AMENDMENTS TO THE DRAWINGS

REMARKS

This paper is responsive to a Non-Final Office action dated April 7, 2006. Claims 1-42 were examined. Claim 23 stands rejected under 35 U.S.C. §112, first paragraph. Claim 23 stands rejected under 35 U.S.C. §112, second paragraph. Claims 1, 2, 8, 10-11, 13-17, 24, 31, and 33-39 stand rejected under 35 U.S.C. § 102(b) as being anticipated by U.S. Patent No. 6,037,649 to Liou et al. Claims 1, 3-5, 7, 20-22, 24, 26-28, and 30 stand rejected under 35 U.S.C. § 102(b) as being anticipated by U.S. Patent Application Publication No. 2002/0109204 to Acosta et al. Claims 1, 2, 8, 12, 20, 23-25, 31, and 42 stand rejected under 35 U.S.C. § 102(e) as being anticipated by U.S. Patent No. 6,653,557 to Wolf et al. Claims 18 and 19 stand rejected under 35 U.S.C. § 103(a) as being unpatentable over Liou. Claims 6, 29, 40, and 41 stand rejected under § 103(a) as being unpatentable over Acosta.

FIG. 9A

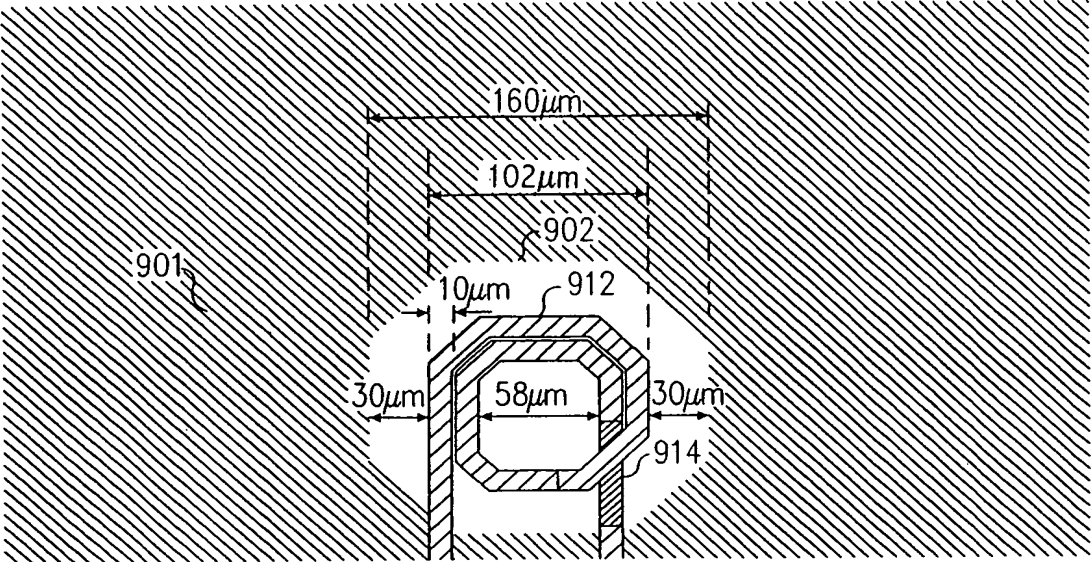
The drawings are objected to as failing to comply with 37 C.F.R. 1.84(p)(5) because they include the following reference characters not mentioned in the description: 1000, 1002, 1004, 1006, 1008, 1010, 1016, and 1066. Figures 9A, 9B, 9C and 10 are amended consistent with the specification.

The attached sheet(s) of drawings include changes to Fig(s). 9A-C and 10 and replace the original sheet(s) including such figures.

Attachment(s): Replacement Sheet including amended Figs. 9A and 9B;
 Annotated Sheet Showing Changes to amended Figs. 9A and 9B.
